Project	IEEE 802.16j Mobile Multihop Relay Task Group		
Title	Enabling MAC tunneling over HARQ in 802.16j		
Date	2007-03-05		
Source(s)	Jeffrey Z. Tao, Koon Hoo Teo, Jinyun Zhang Mitsubishi Electric Research Lab 201 Broadway Cambridge, MA 02139 USA	Voice: 617-621-{7557,7527} Fax: 617-621-7550 {tao, teo, jzhang}@merl.com	
	Toshiyuki Kuze, Shigeru Uchida, Kentarou Sawa Mitsubishi Electric Corp 5-1-1 Ofuna Kamakura, Kanagawa 2478501, Japan	Voice: +81-467-41-2885 Fax: +81-467-41-2486 Kuze.Toshiyuki@ah.MitsubishiElectric.co.jp	
	Jerry Sydir, Kerstin Johnsson, Hyunjeong Lee Intel Corporation 2200 Mission College Blvd., Santa Clara, CA 95054, USA	jerry.sydir@intel.com	
	Tzu-Ming Lin, Wern-Ho Sheen, Fang-Ching Ren, Jen-Shun Yang, Chie Ming Chou, I-Kang Fu, Ching-Tarng Hsieh, Jui-Tang Wang Industrial Technology Research Institute (ITRI)/ National Chiao Tung University (NCTU), Taiwan 195,Sec. 4, Chung Hsing Rd. Chutung, Hsinchu, Taiwan 310, R.O.C.	jsyang@itri.org.tw

Enabling MAC Tunneling over HARQ in 802.16j

Figure 1: Insertion of PDU SN extended subheader.

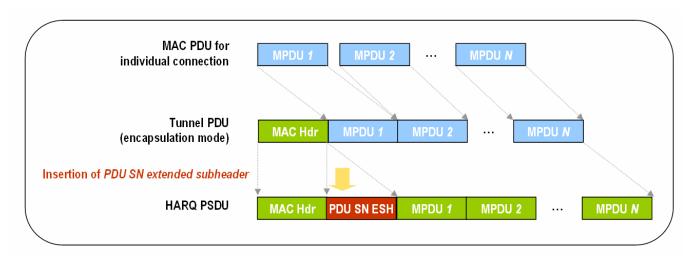
- 1. Tunnel identification in HARQ: When handled by HARQ, a MAC tunnel shall be perceived as one single connection. Thus, it is a natural solution to use the tunnel CID [1] in the RCID field.
- **2. Out-of-order data delivery:** To address this problem, a PDU sequence number (SN) extended subheader shall be inserted immediately after the tunnel header, as shown in Figure 1.

If a tunnel PDU that is constructed by using encapsulation will be processed by parallel HARQ channels, the tunnel PDU then shall contain a PDU SN extended Subheader after the tunnel header.
